Title: MV A/C Condenser Hose Interference with Inner Hood

Applies To: MV

This document will guide a technician to change clamp locations to prevent future rubbing of the upper A/C condenser hose along the inner portion of the hood.

**Figure #4: Original design:** Note clamp location prior to disassembly.

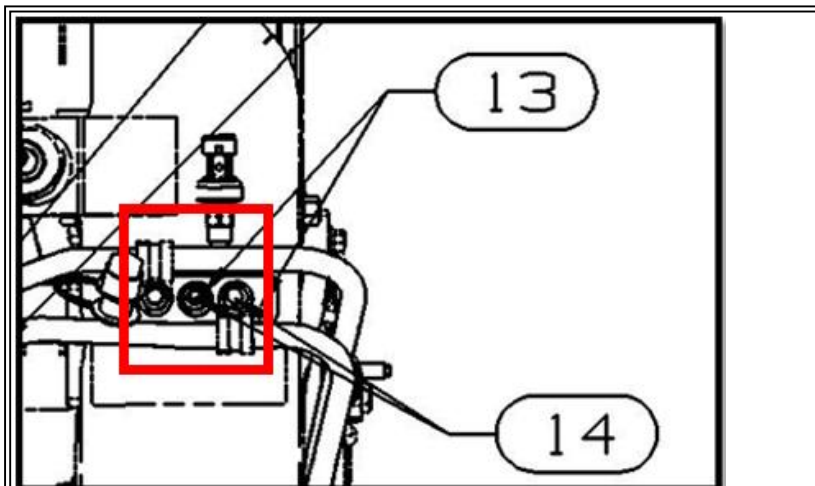
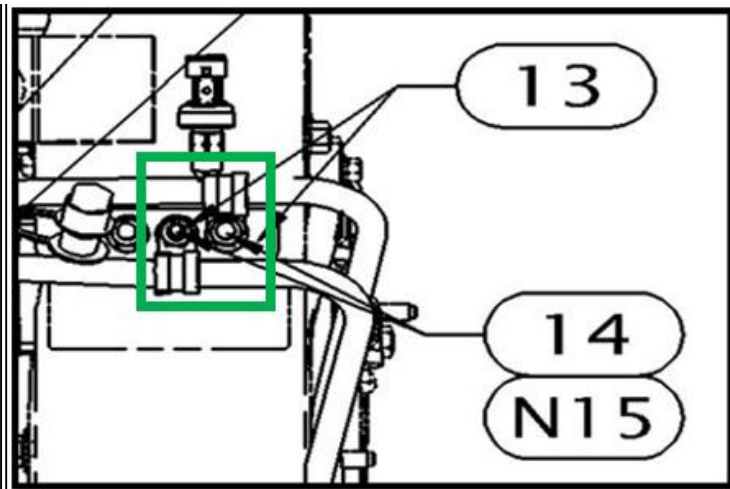
Figure #5: **Updated design:** Relocating both clamps will prevent the upper hose with further contact of the hood.

1. During installation of a new hose(s), relocate both clamps during assembly see figure #2.
2. Secure each hose properly by ensuring there are no contact points with the inner portion of the hood assembly.
3. Complete repairs by correcting oil and charge levels listed within the **2017 - 2020 MV Technician Manual (Service and Diagnostic) 0000993280 (HVAC testing)**.
